# DEVELOPMENT REVIEW COMMITTEE (DRC) COMMENT REPORT

**PROJECT NAME:** 4545 N. Federal Highway

**CASE NUMBER:** PLN-SITE-20090001

**REQUEST:** Site Plan Level II Review: 11,865 Square-Foot Medical Office Use and 10,261 Square-Foot Office Building

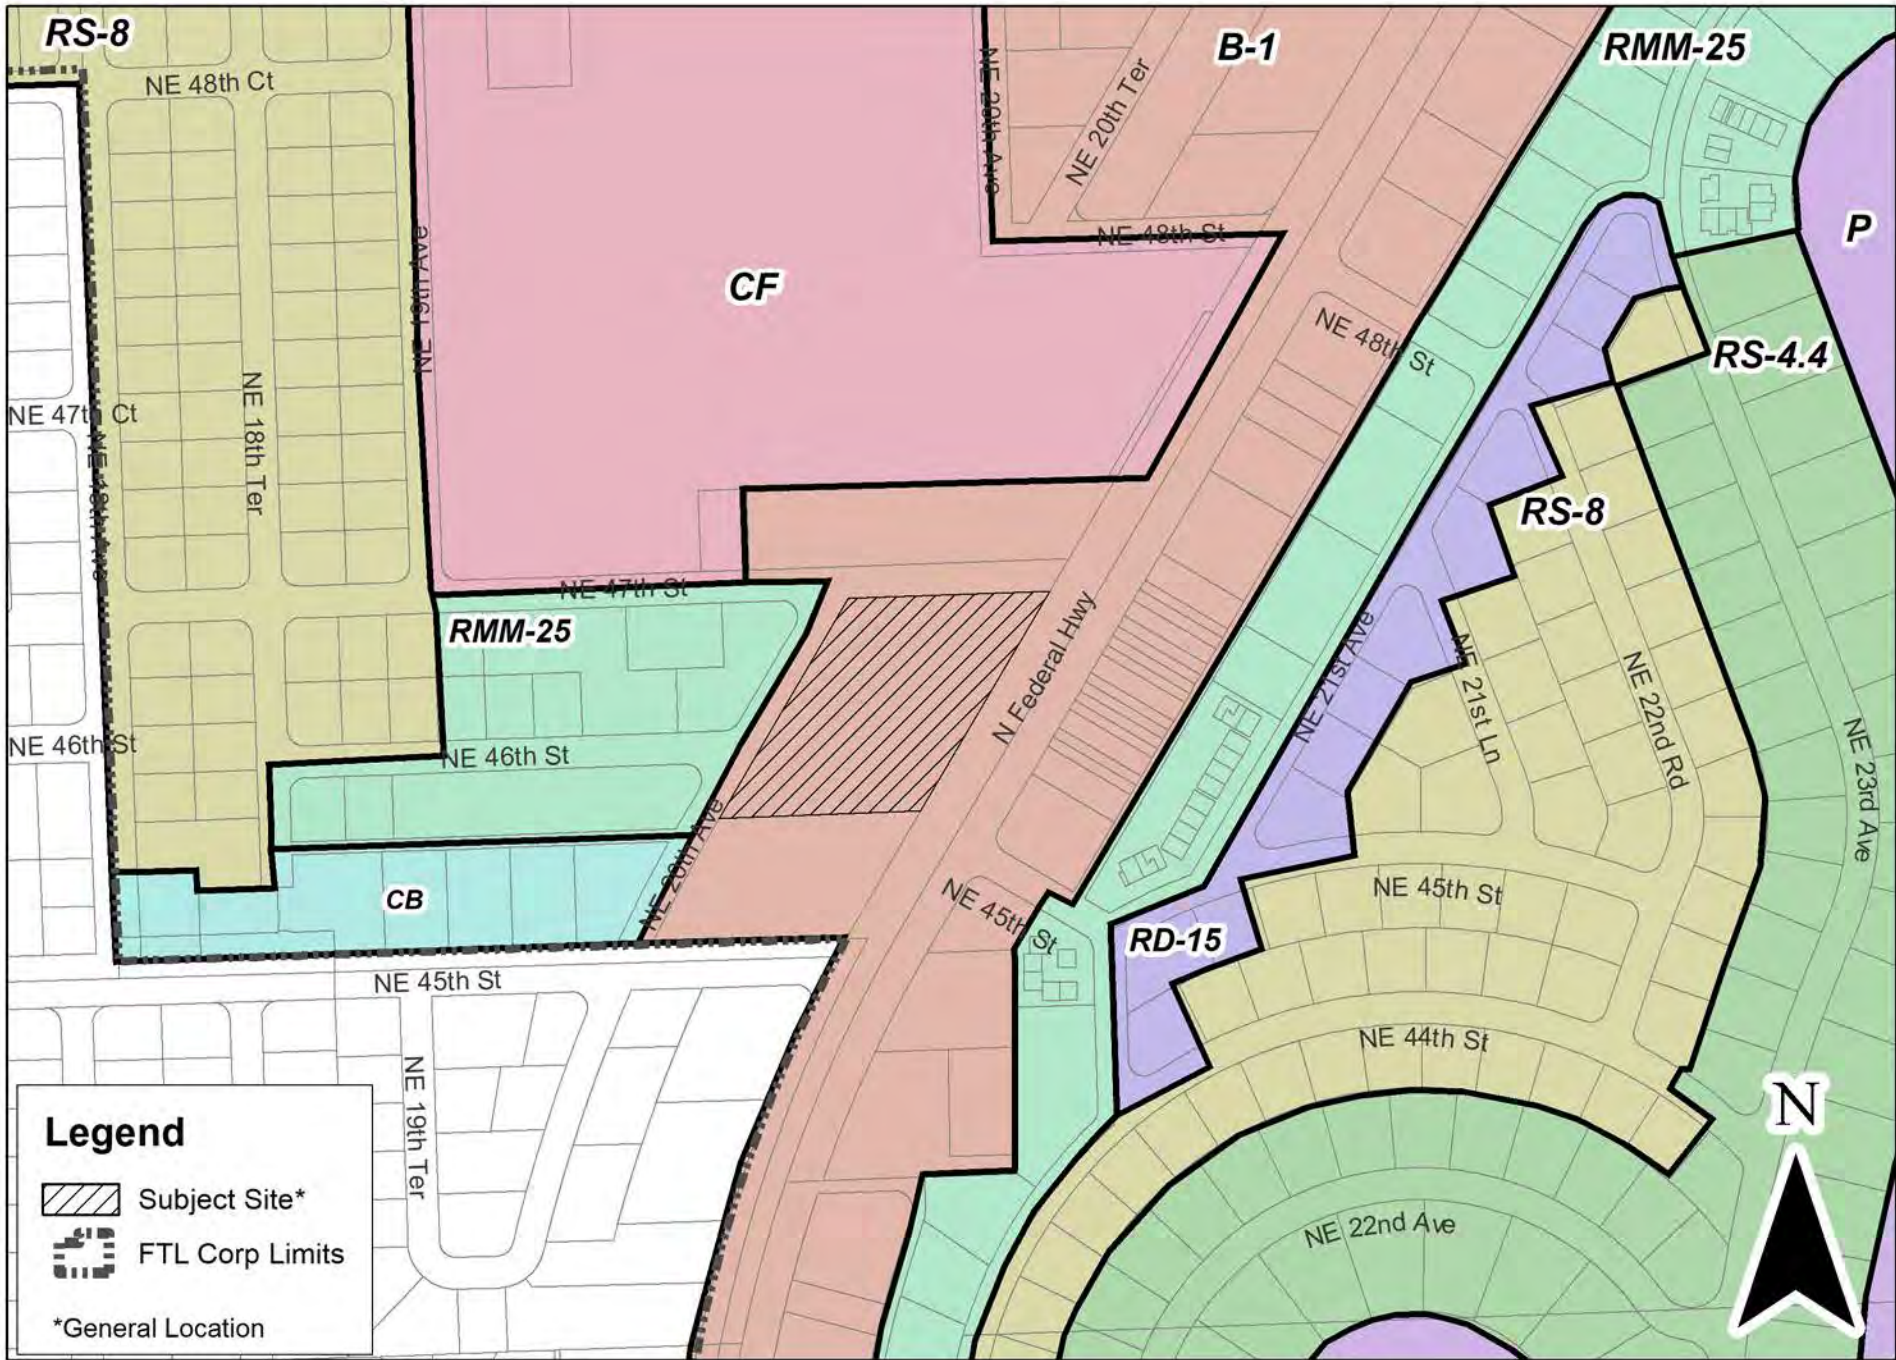
- d. Provide roadway centerline measurements to property boundary.

- e. The western property line serves as a transitional zone between higher intensity uses along Federal Highway and the abutting residential neighborhood. To meet the intent of Section 47-25.3., Neighborhood Compatibility Requirements, provide additional landscaping along the western property line to screen the parking lot along Northeast 20<sup>th</sup> Avenue.
